Architectural Review Board Staff Report

Project Type:	Amended Architectural Elevations
Meeting Date:	April 12, 2018
From:	Cassie Harashe, Project Planner
Location:	South side of Chesterfield Airport Rd., west of Chesterfield Commons Dr.
Description:	<u>Chesterfield Commons, Lot 13 (St. Louis Bread Co.) Amended Architectural Elevations:</u> Amended Architectural Elevations and Project Narrative for a 1.3 acre tract of land zoned “C-8” Planned Commercial District located on the south side of Chesterfield Airport Rd., west of Chesterfield Commons Drive.

Remodel Exterior Elevations Package

17132 Chesterfield Airport Road
Chesterfield, MO 63005

Figure 4. Proposed Color North Elevation

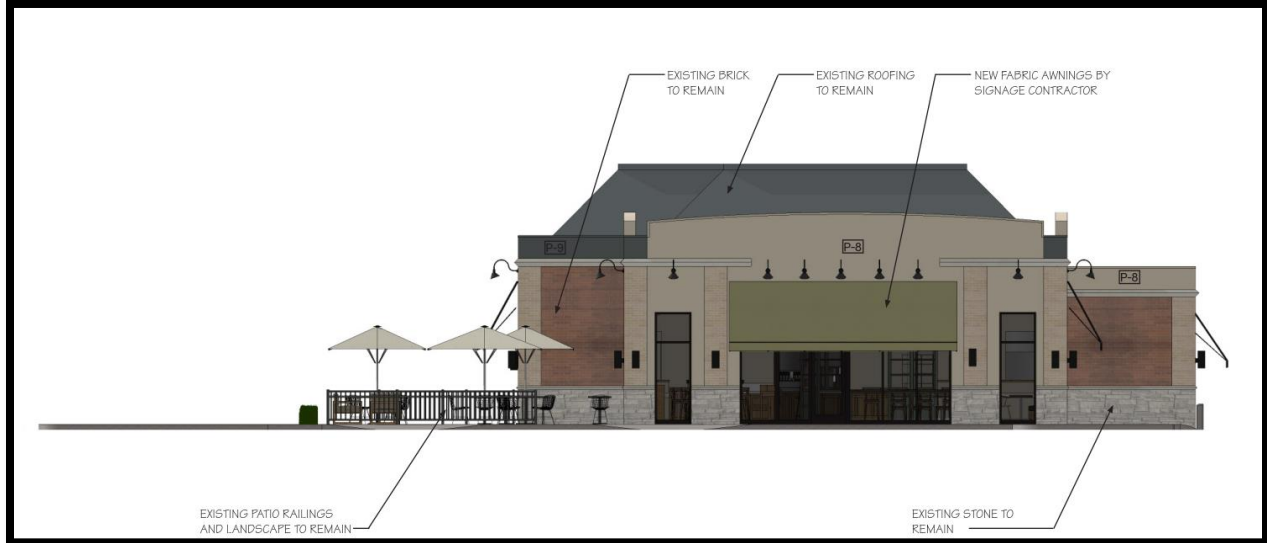
The primary design includes existing elements of the building that are common within the Chesterfield Commons development. Most notably, the existing brick utilized throughout the development will remain on the building. The proposed color palette for the building includes utilizing the existing red brick, repainting the existing green EFIS accent panels with Berber White color, and the yellow EFIS accent band near the top of the building will be repainted a Rocky Coast Grey. The patterned fabric canopies will be replaced with a green fabric canopy.

ELEVATION 1 - PATIO REMODEL (East Facade)

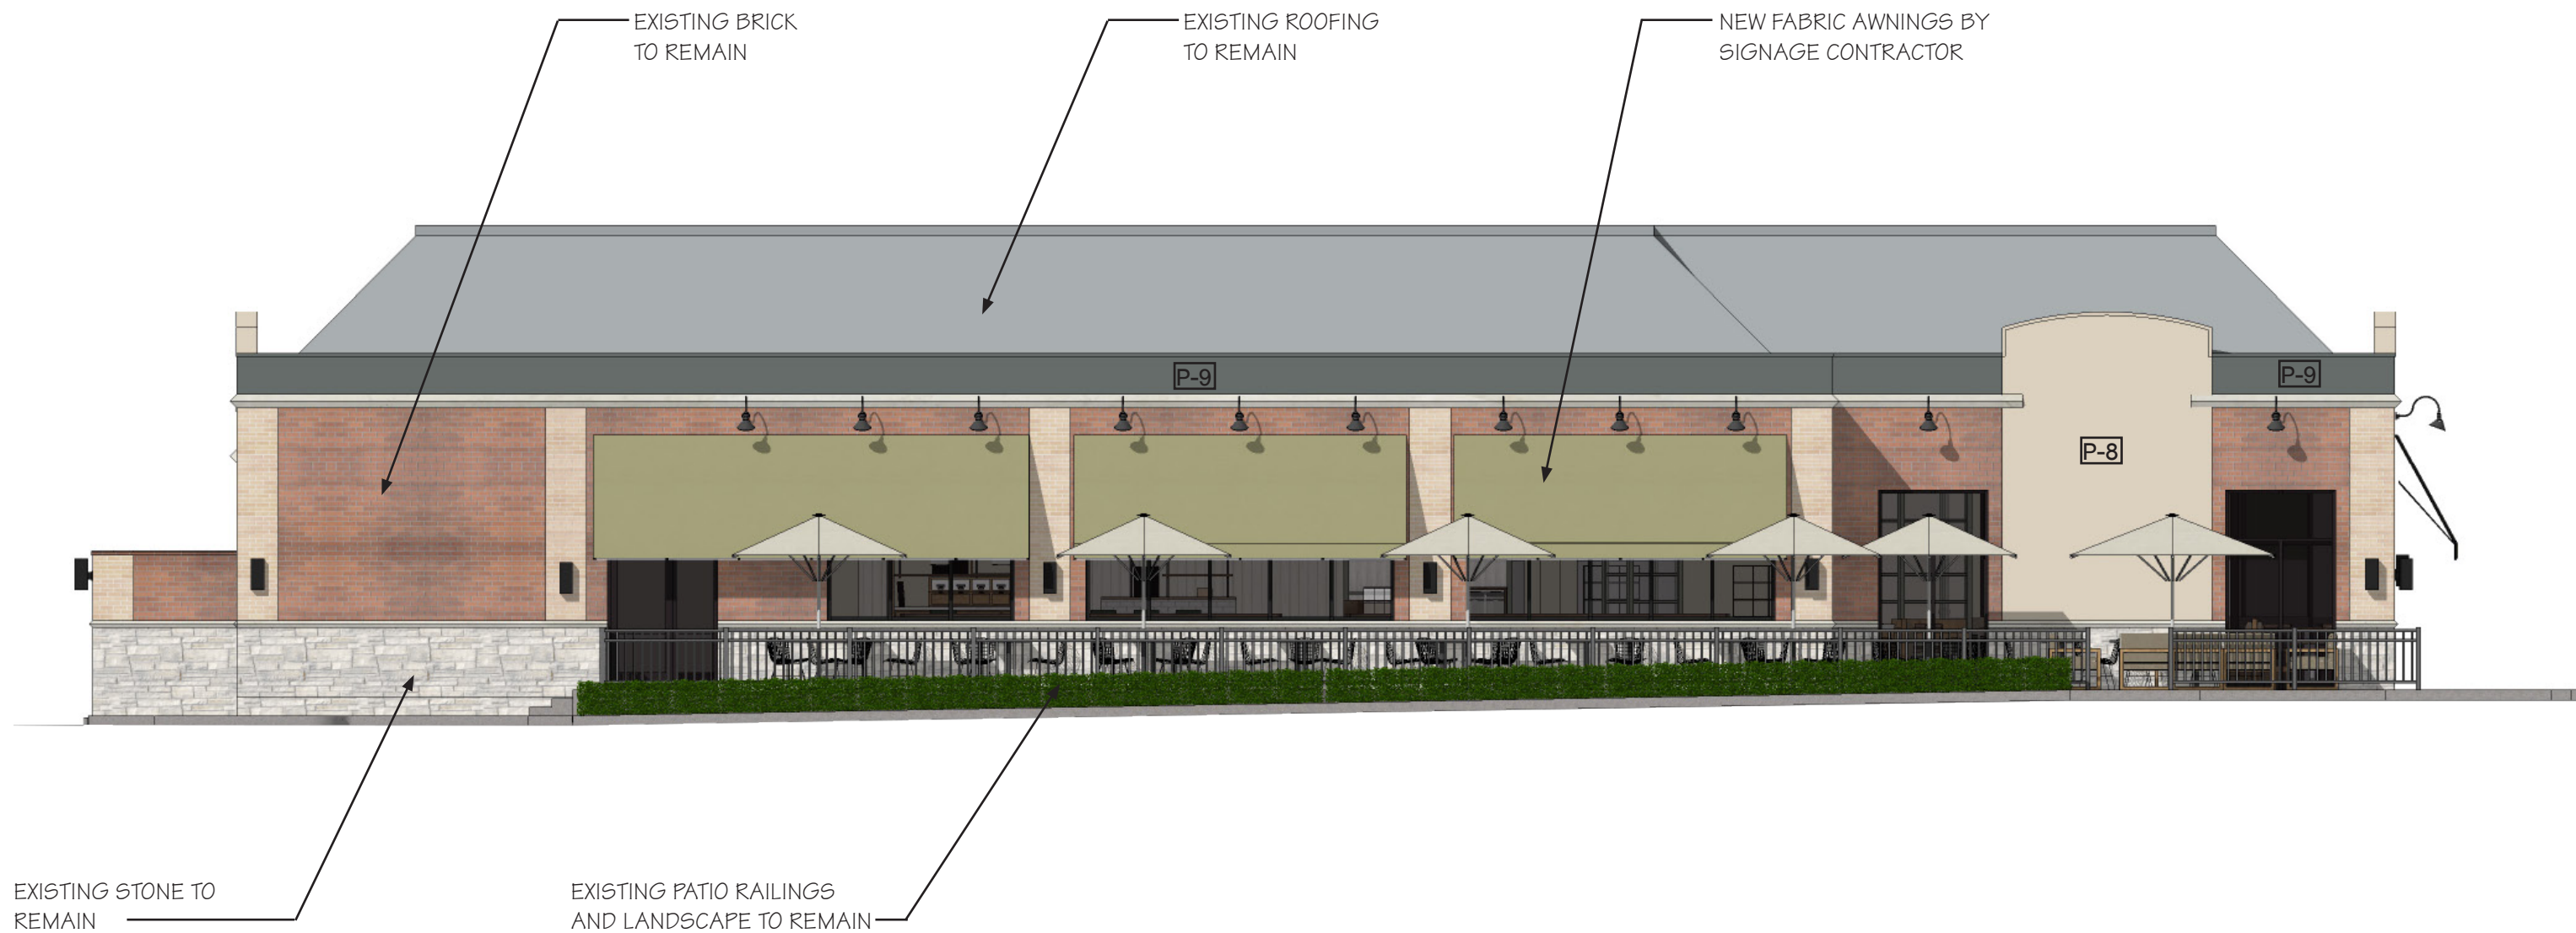
P-8 Exterior Facade Benjamin Moore Windsbreath	P-9 Exterior Facade Benjamin Moore Rocky Coast
--	--

ELEVATION 3 - DRIVE THRU REMODEL (West Facade)

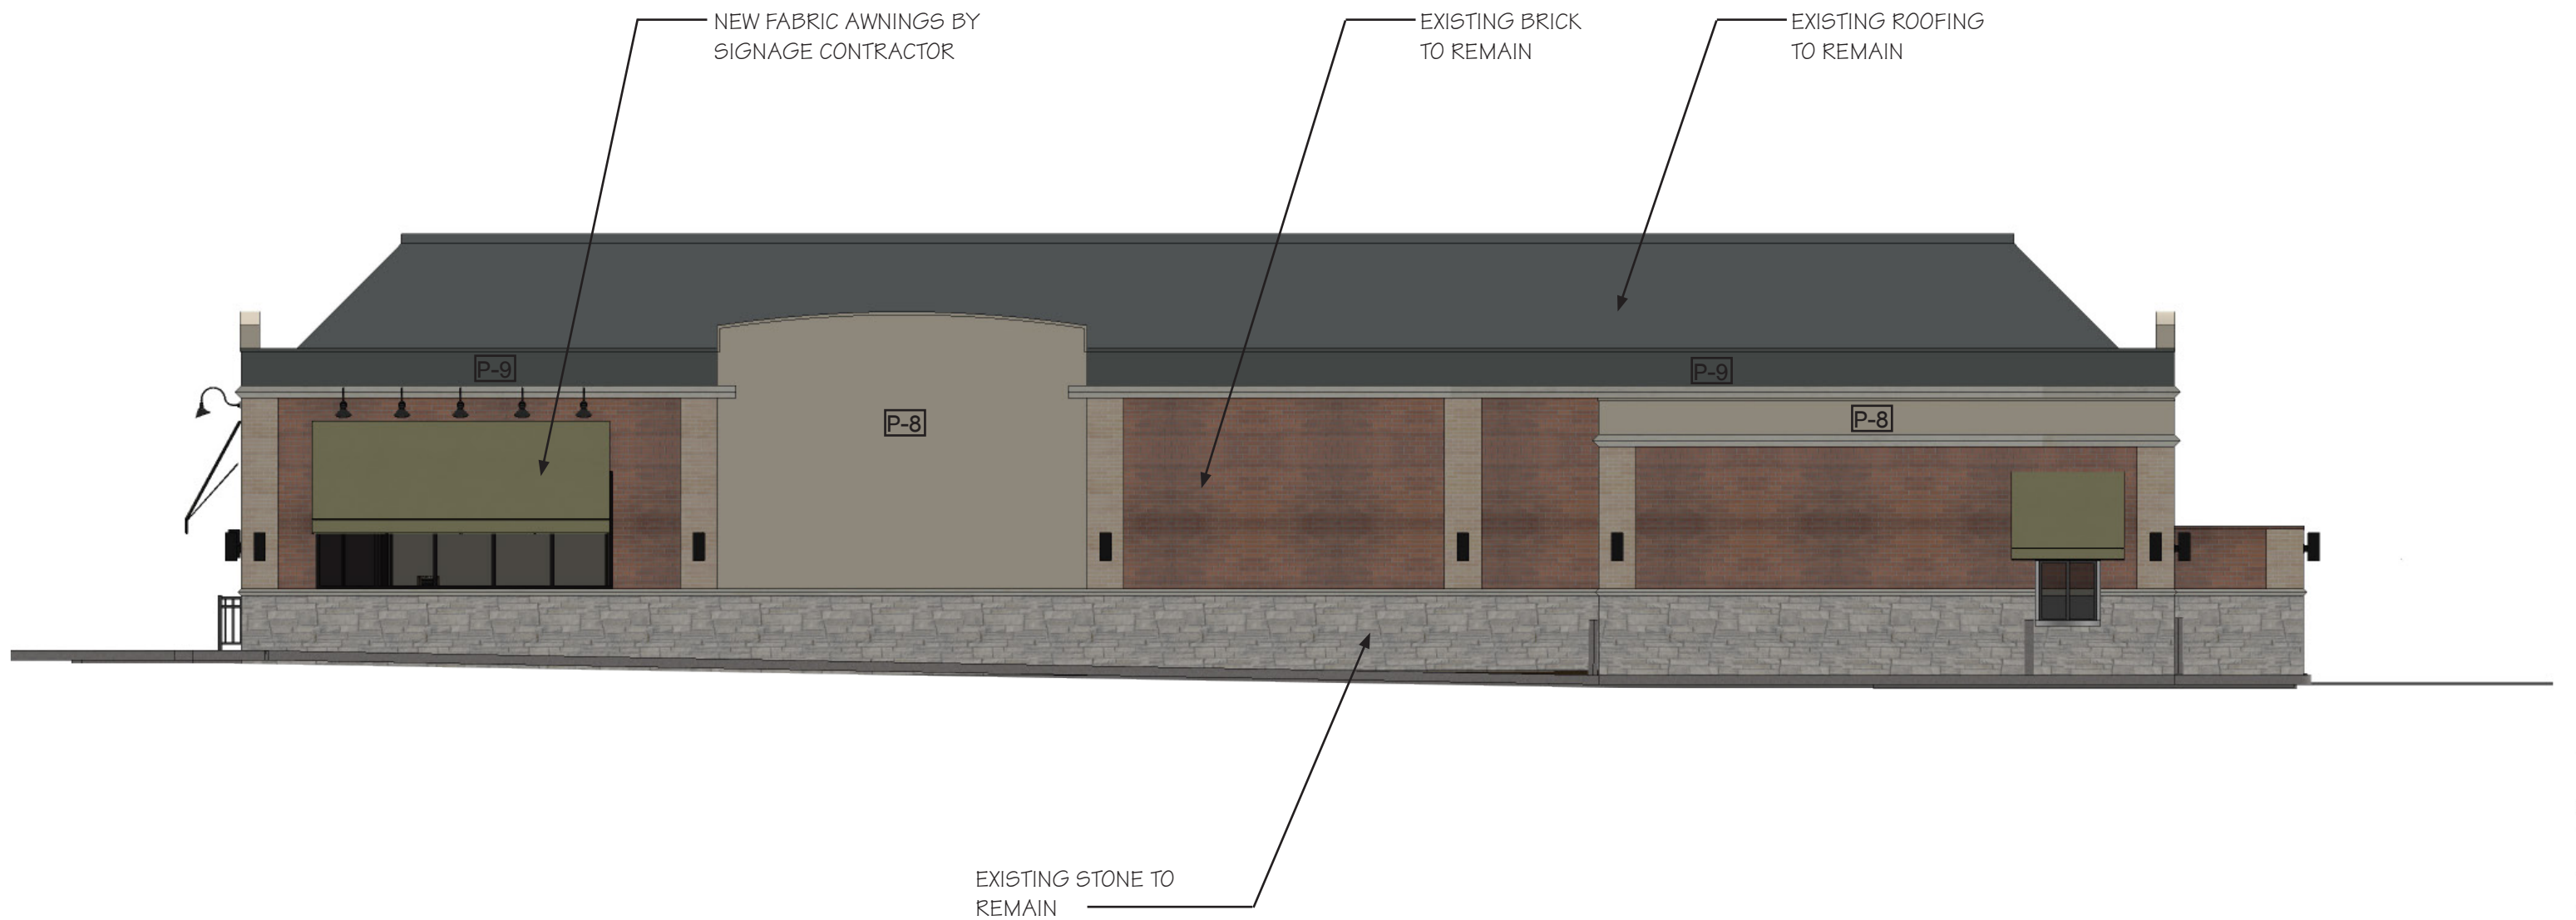
P-8	Exterior Facade Benjamin Moore Windsbreath	P-9	Exterior Facade Benjamin Moore Rocky Coast
-----	--	-----	--

ELEVATION 4 - REAR REMODEL (South Facade)

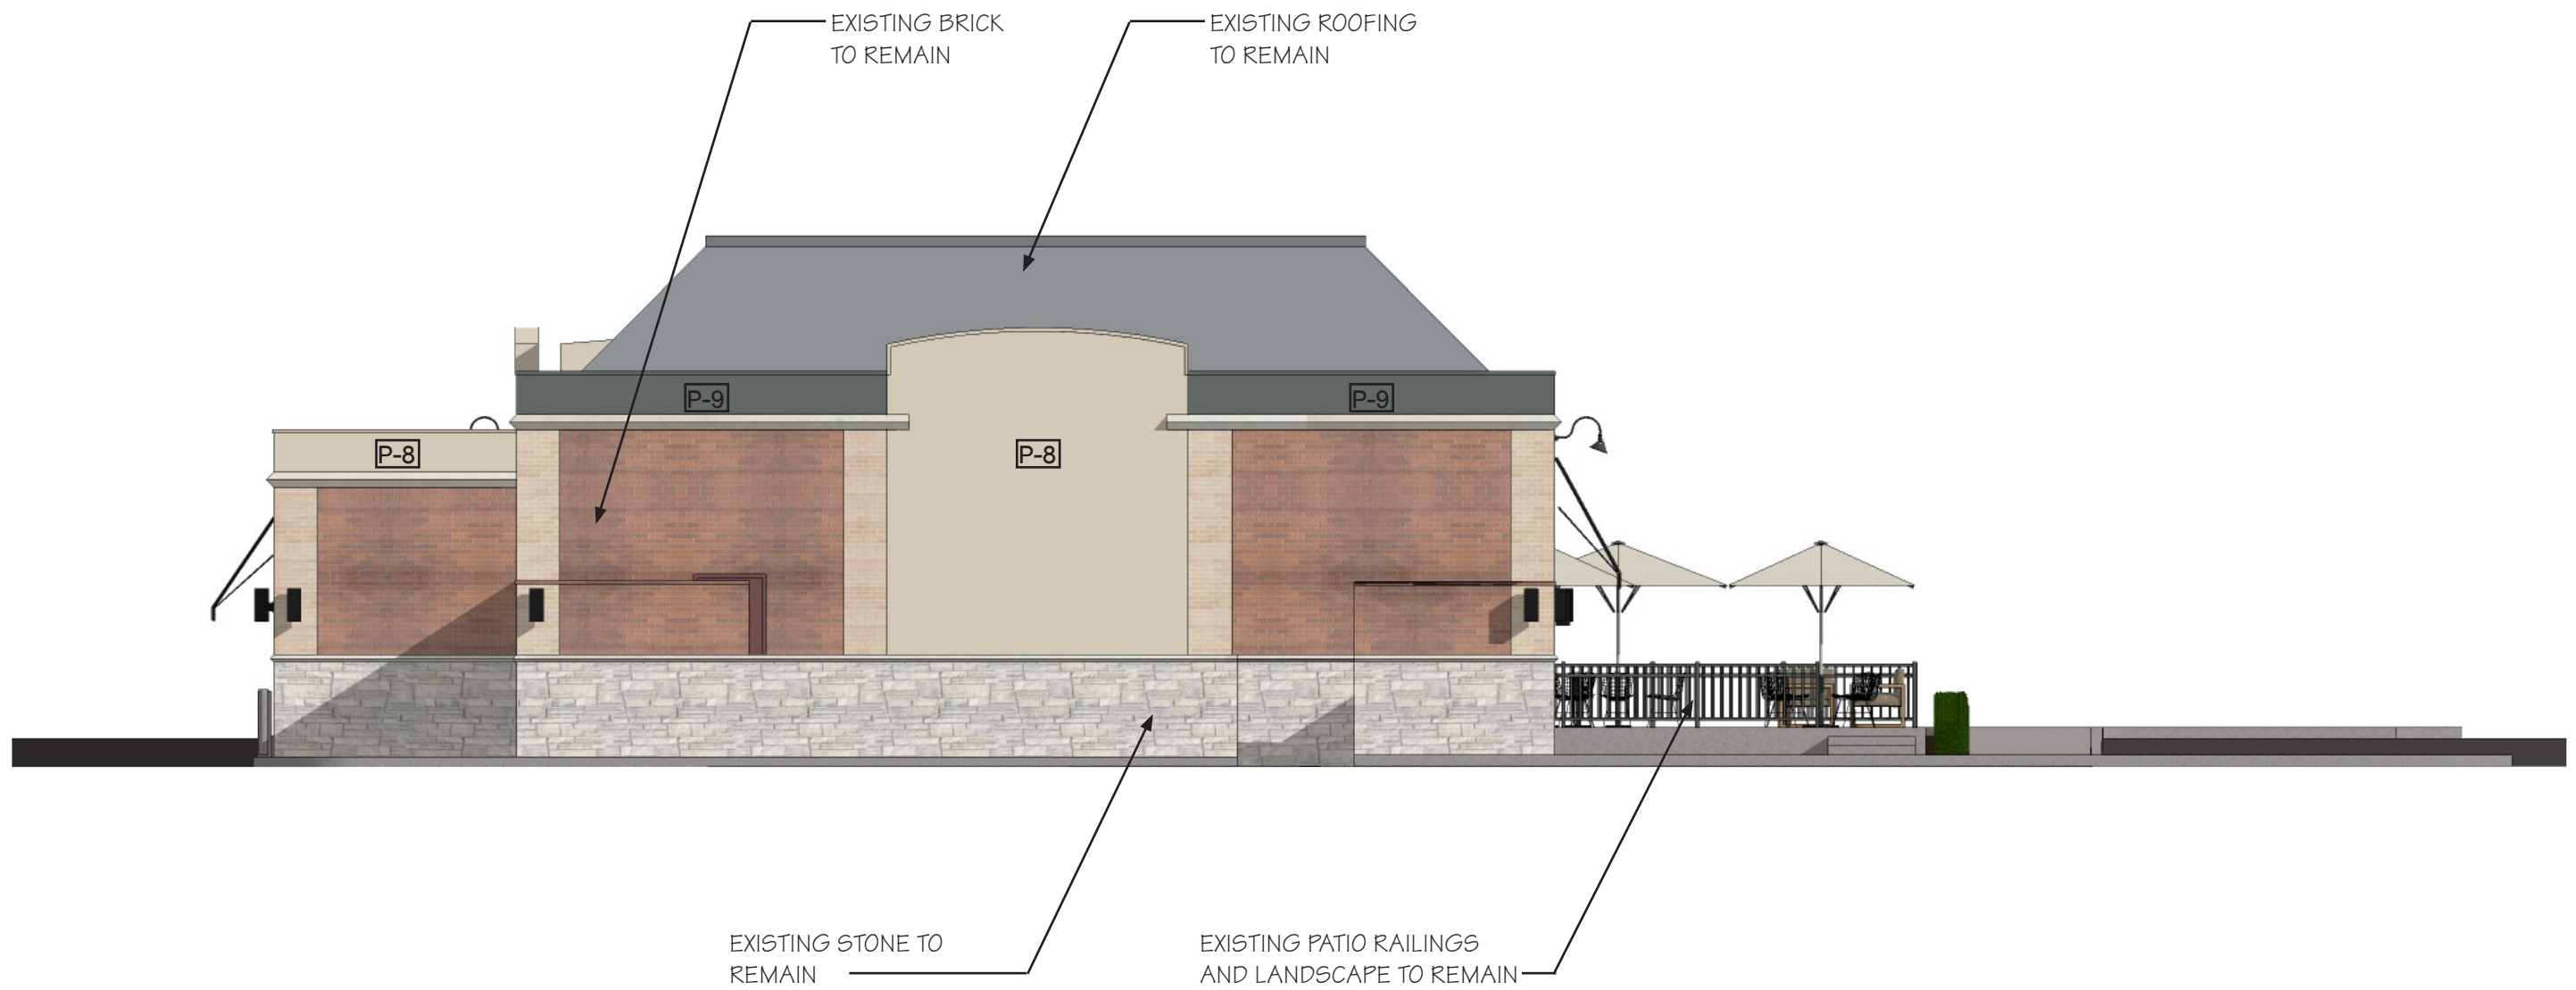
<p>P-8 Exterior Facade Benjamin Moore Windsbreath</p>	<p>P-9 Exterior Facade Benjamin Moore Rocky Coast</p>
--	--
